Status: Y N U**Seismic Walkdown Checklist (SWC)**Equipment ID No. 1-1805-53-015 Equip. Class¹² ZEquipment Description 480V Switchgear 1AD15Location: Bldg. Aux/41 Floor El. 119'-3" Room, Area RD105

Seismic Walkdown Checklist (SWC)

Equipment Description 125 VDC BATTERY 1BD1B

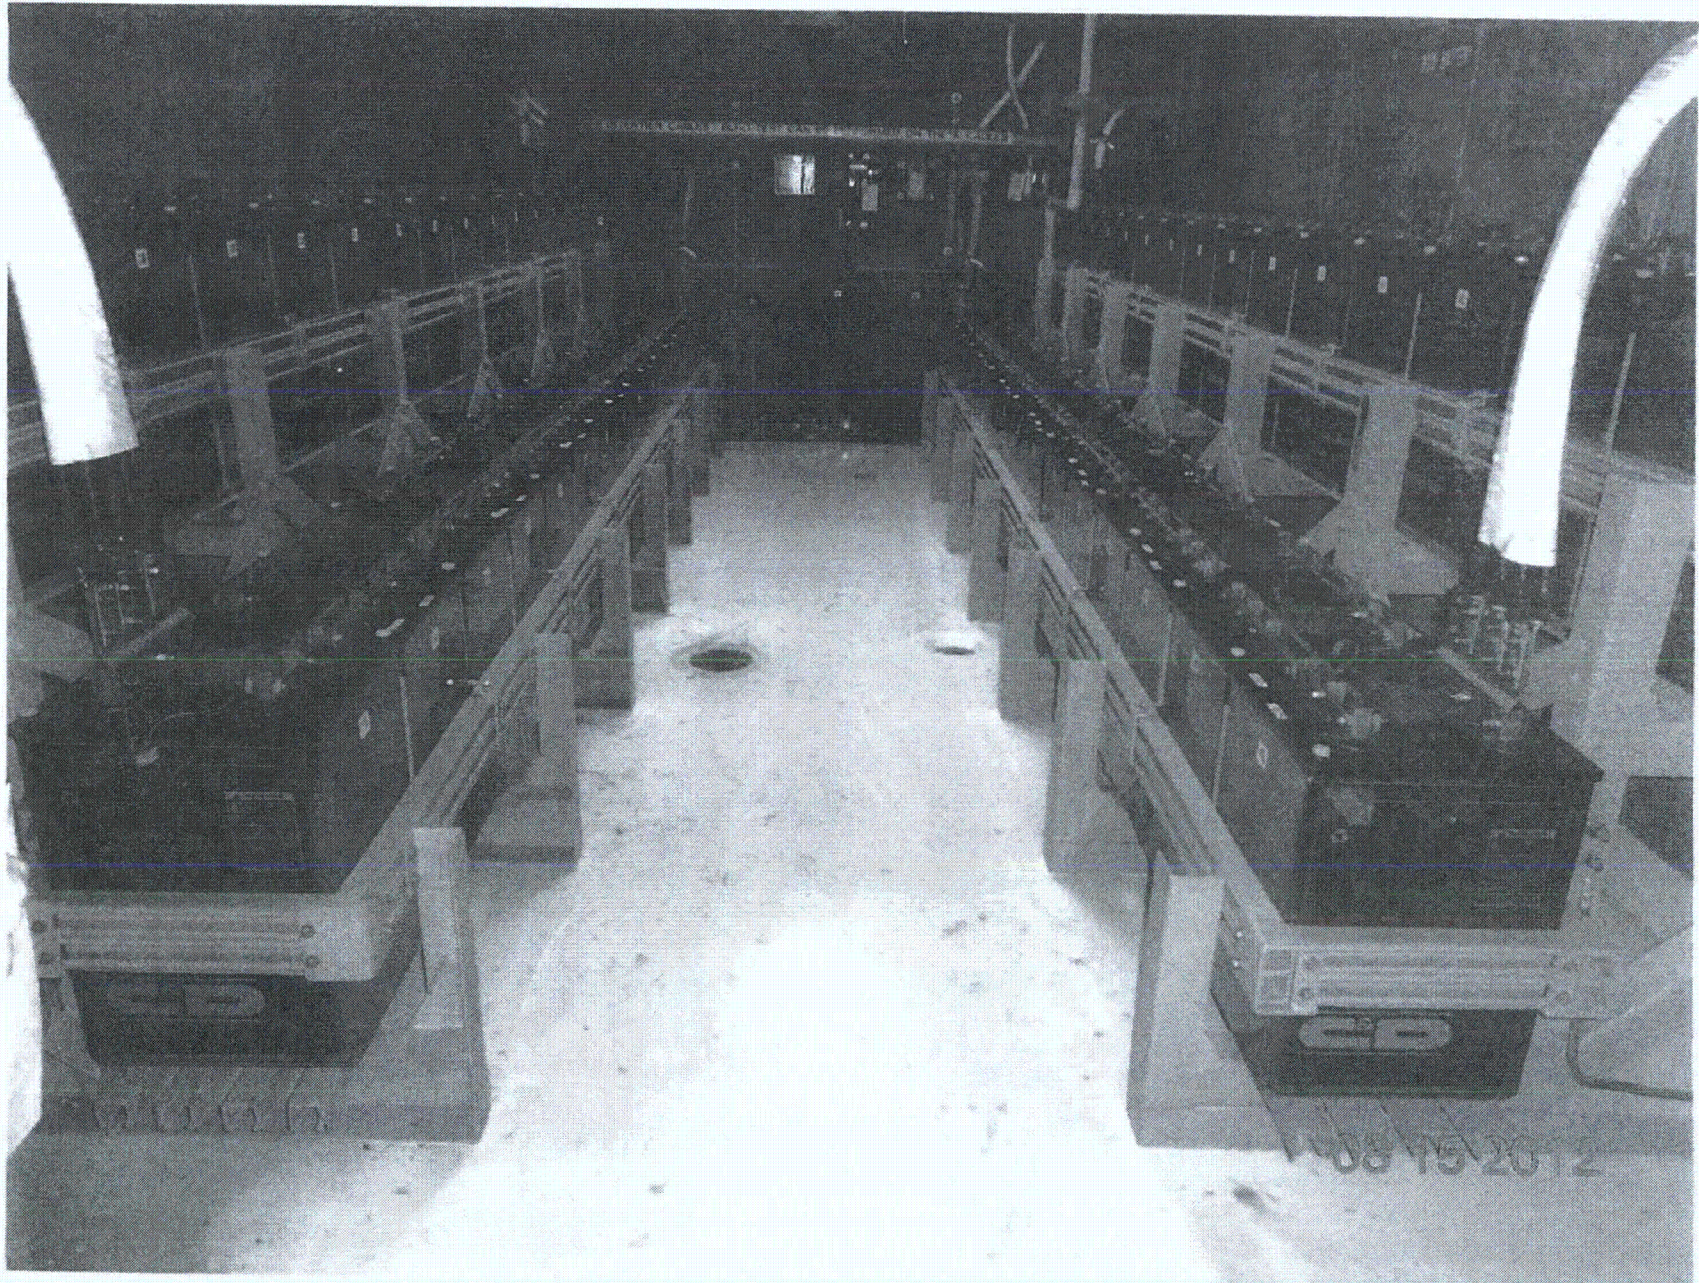
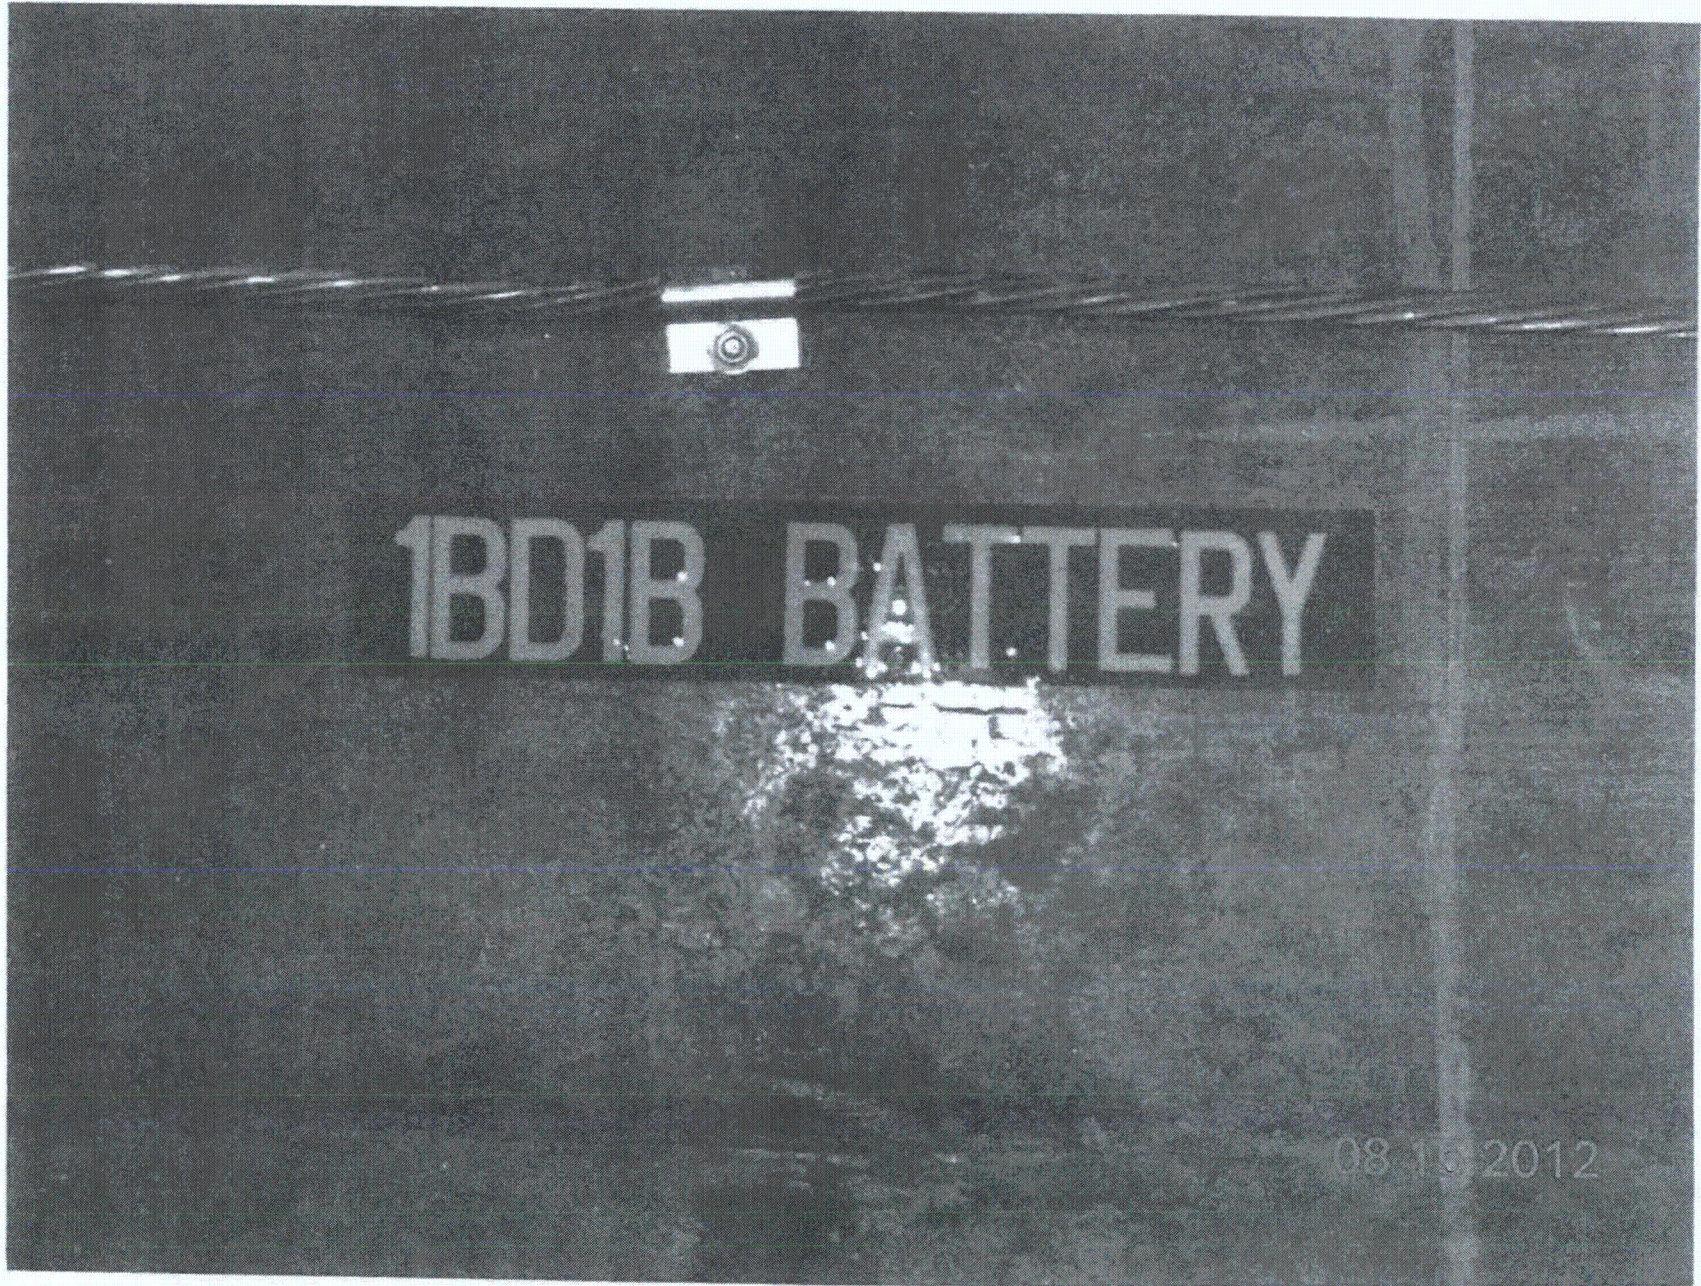
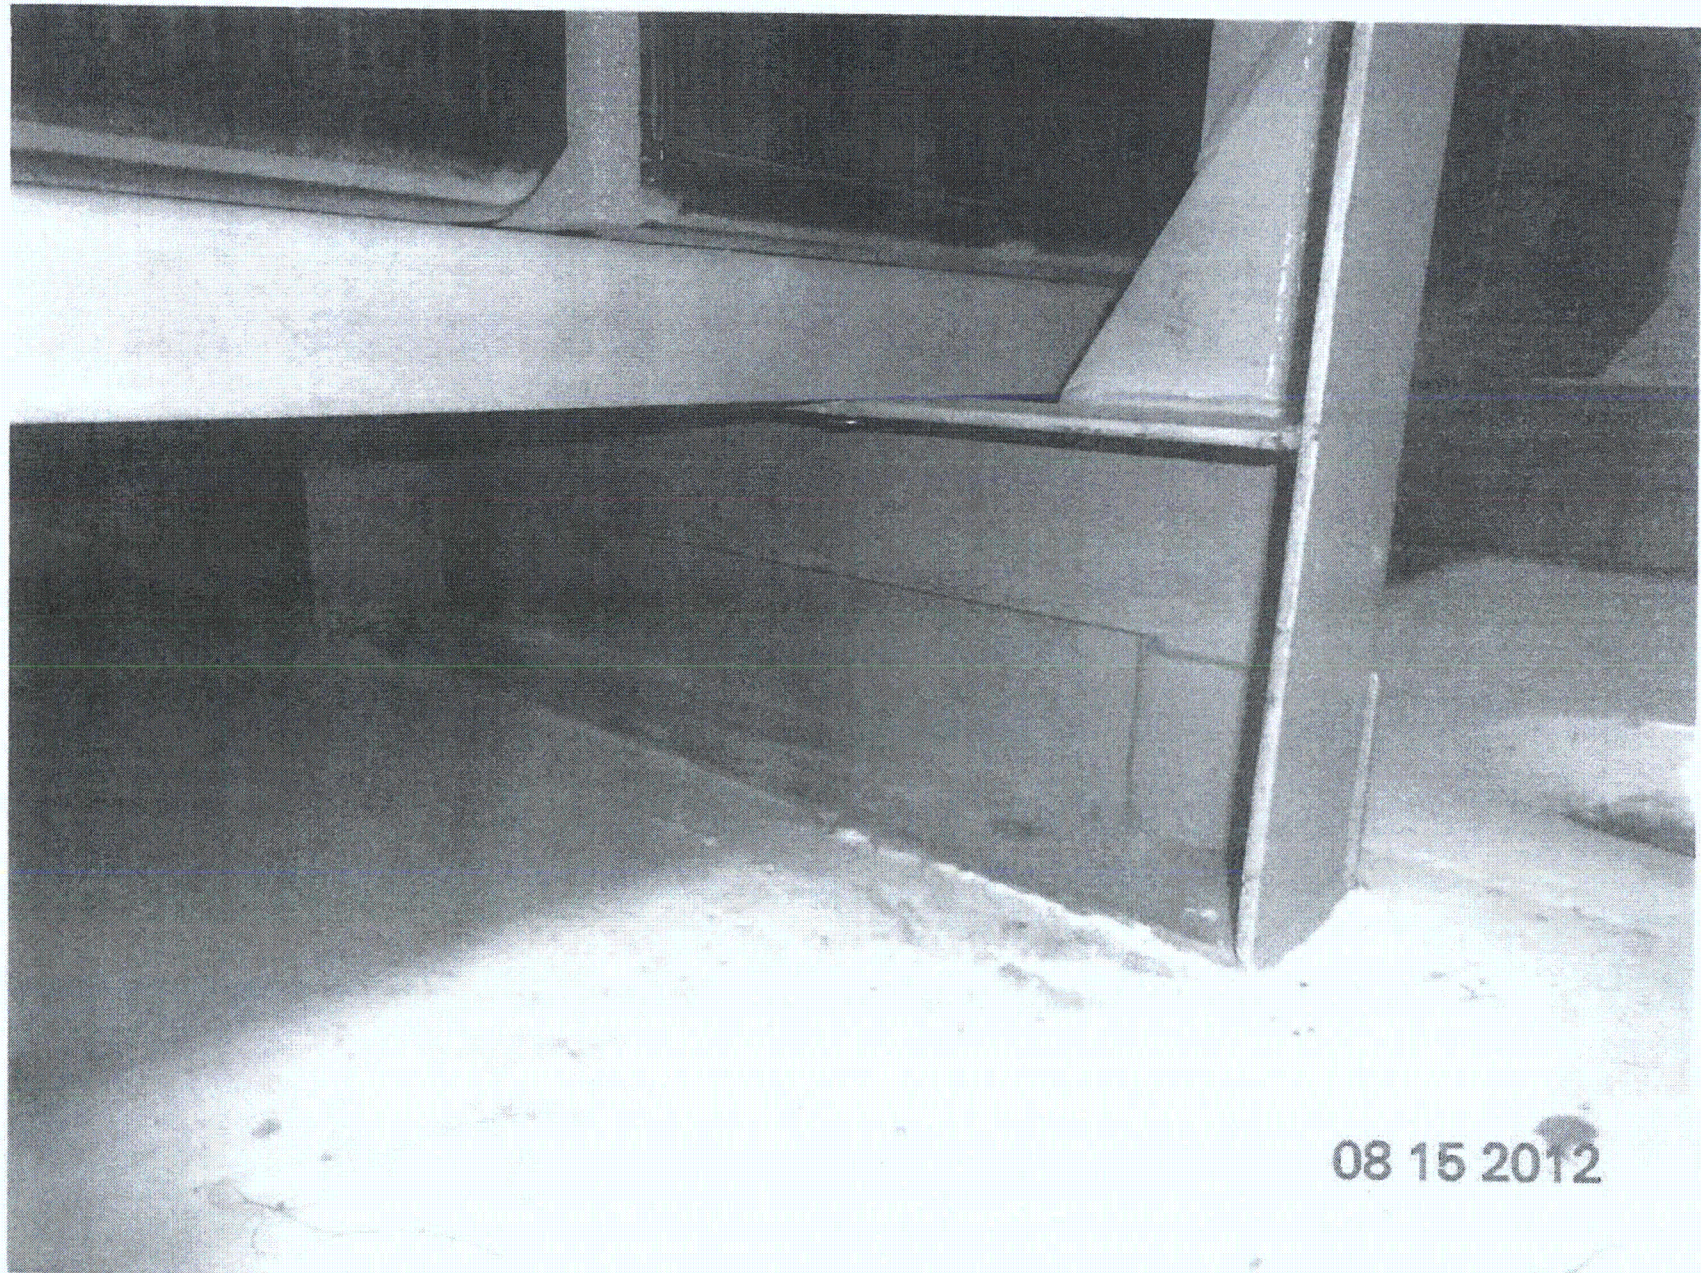
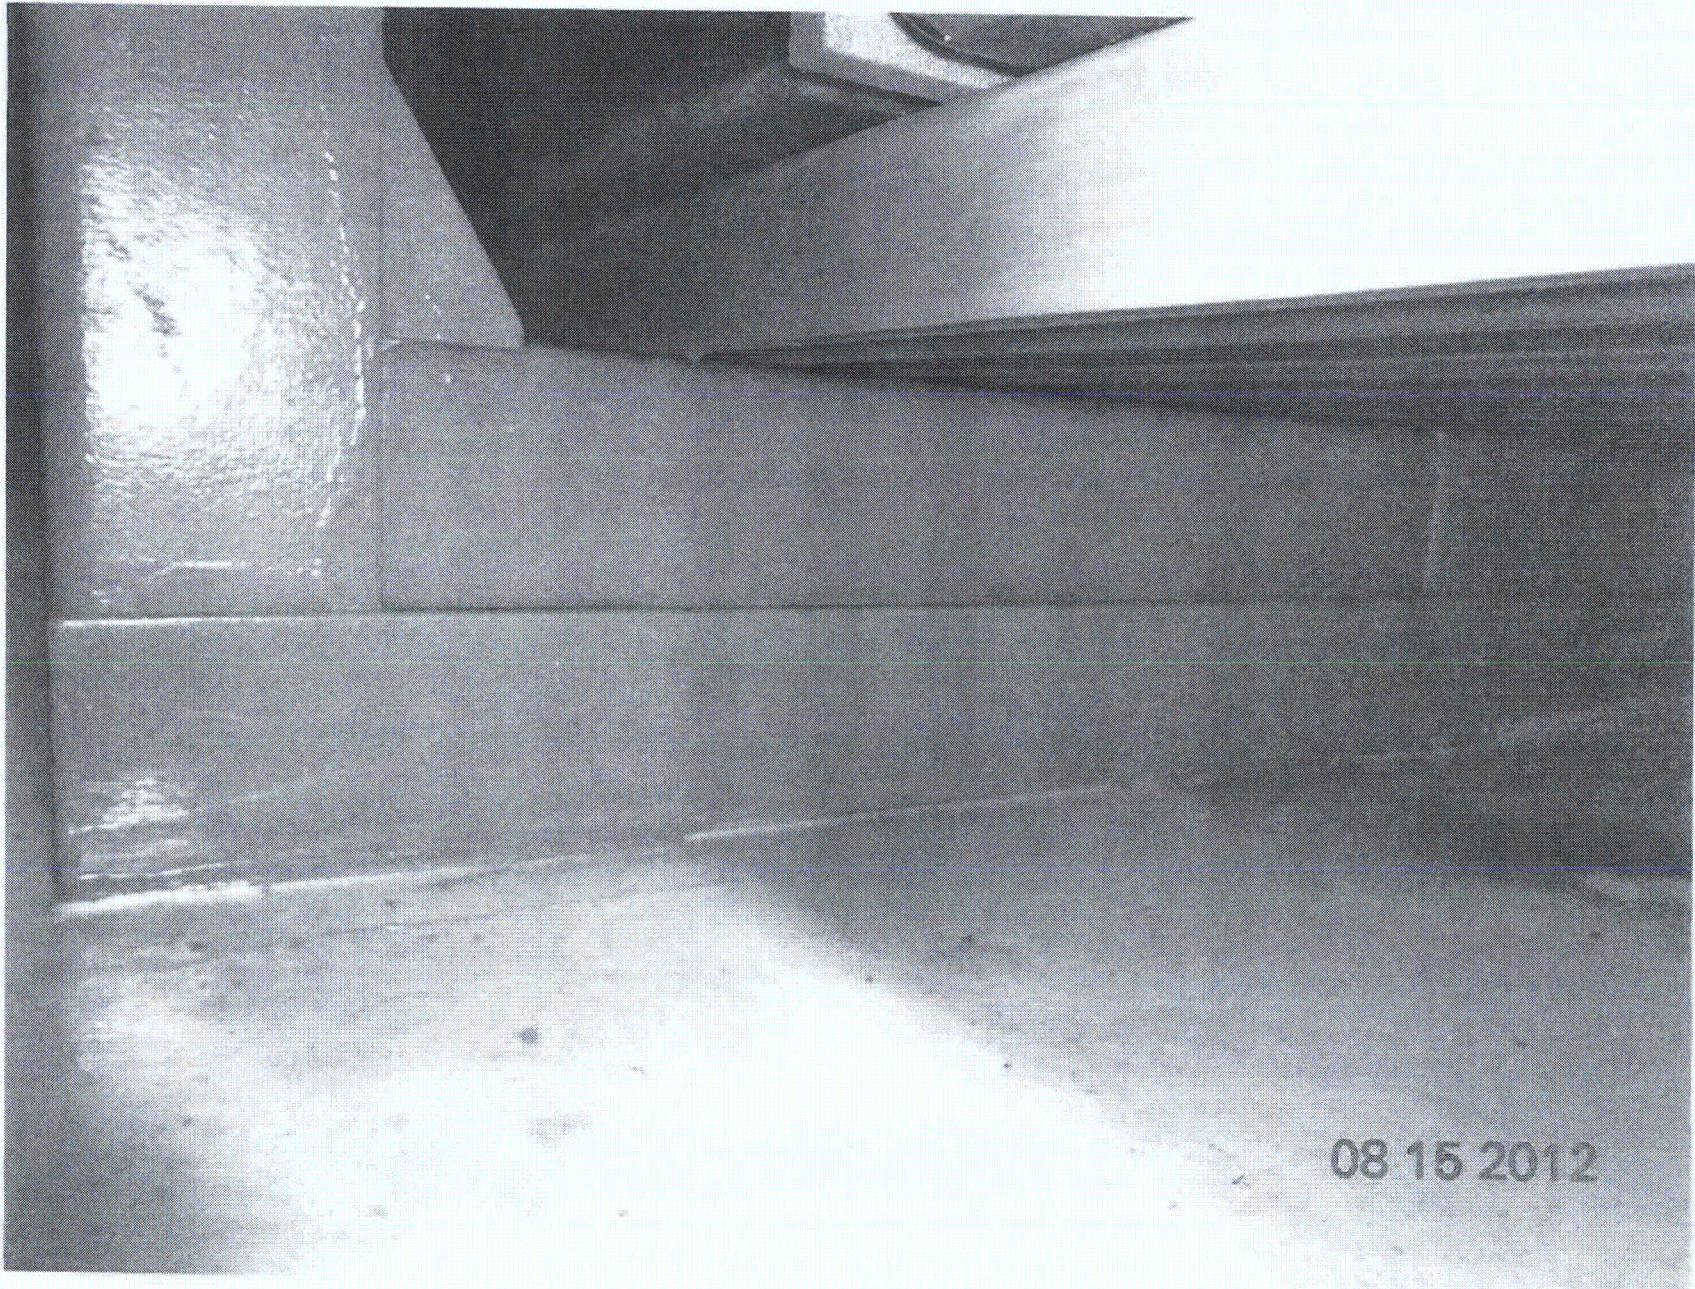
(Note: This question only applies if the item is one of the 50% for which an anchorage configuration verification is required.)
WELD APPEARS TO BE UNDERSIZED AT FEW LOCATIONS. HOWEVER, CONSIDERING THE AMOUNT OF WELD AND WELD PATTERN, THE EXISTING WELDS ARE SUFFICIENT TO SUPPORT BATTERY RACK. REFER TO EQDP# X3AD01 REV.0 FOR WELD CONFIGURATION
